DONALD C. COOK NUCLEAR PLANT, UNIT NO. 1

AMENDMENT TO FACILITY OPERATING LICENSE

Amendment No. 152
License No. DPR-58

AMENDMENT NO. 152 TO FACILITY OPERATING LICENSE NO. DPR-58

FIGURE 2.1-1 REACTOR CORE SAFETY LIMITS

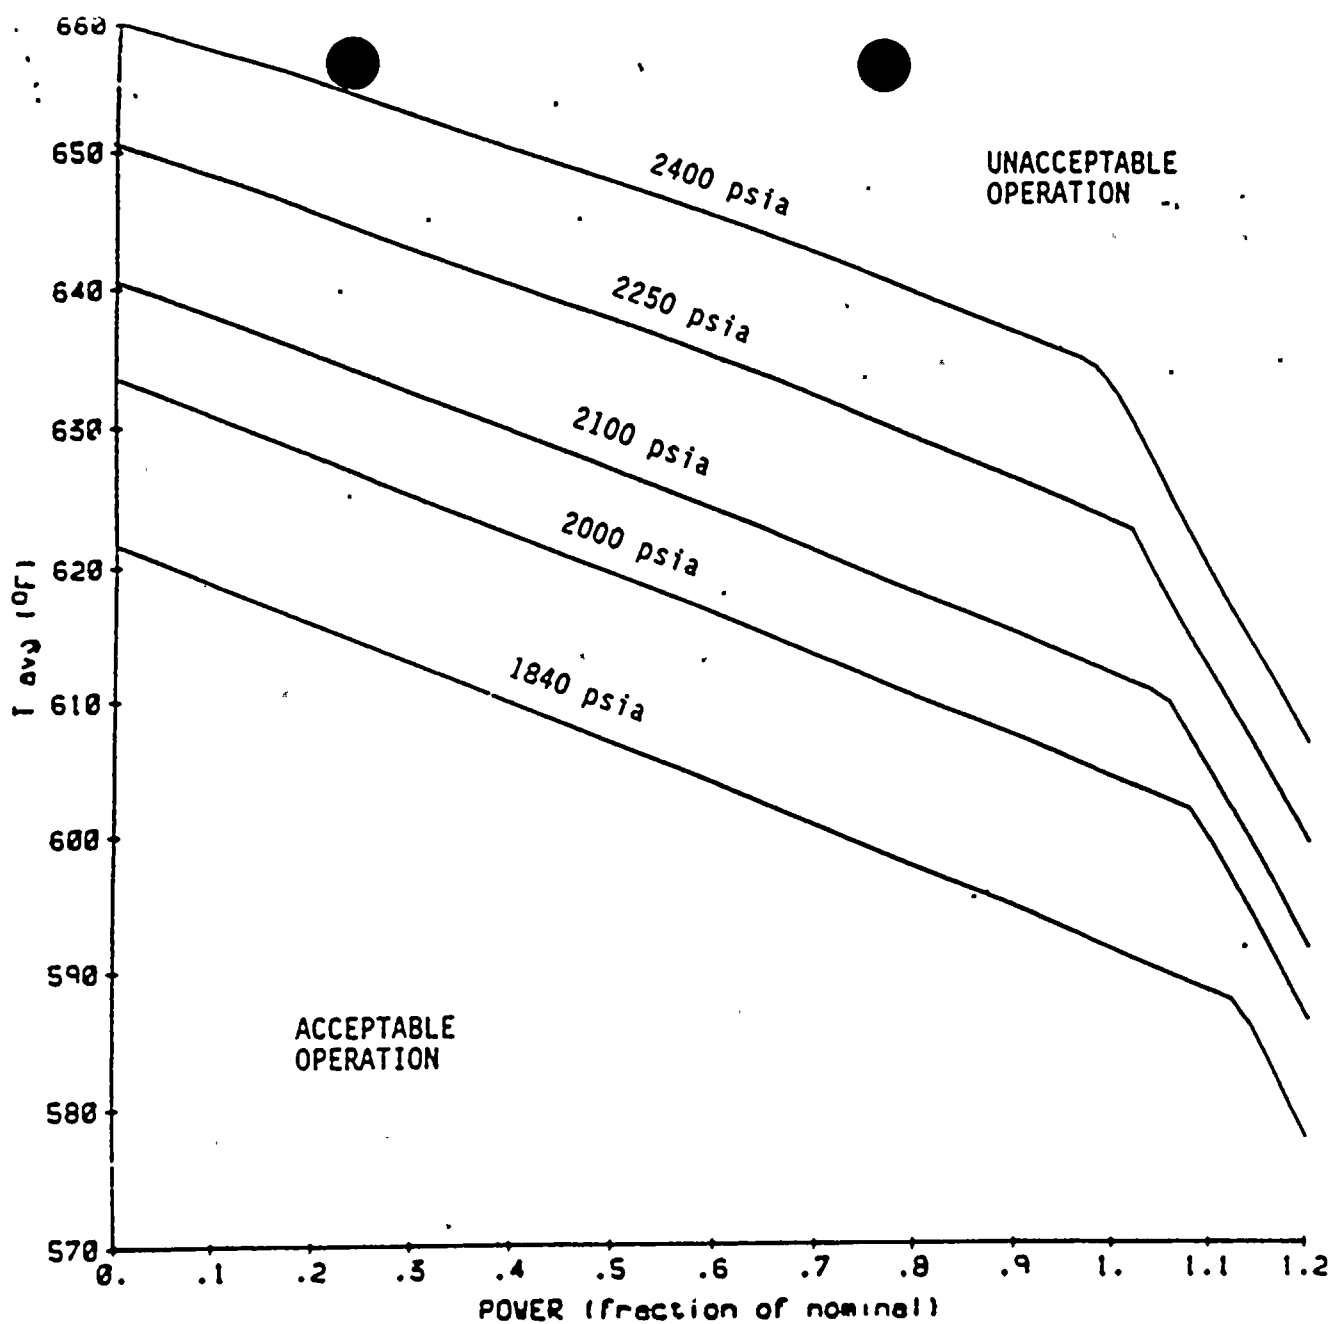
Revise Appendix A Technical Specifications by removing the pages identified below and inserting the attached pages. The revised pages are identified by amendment number and contain marginal lines indicating the area of change.

PRESSURE (PSIA)	BREAKPOINTS (FRACTION RATED THERMAL POWER, T-AVG IN DEGREES F)
1840	(0.0, 622.1), (1.13, 587.3), (1.20, 577.5)
2000	(0.0, 633.8), (1.08, 601.4), (1.20, 586.0)
2100	(0.0, 640.8), (1.06, 609.8), (1.20, 591.3)
2250	(0.0, 650.7), (1.02, 621.9), (1.20, 598.9)
2400	(0.0, 660.1), (0.98, 633.7), (1.20, 606.2)
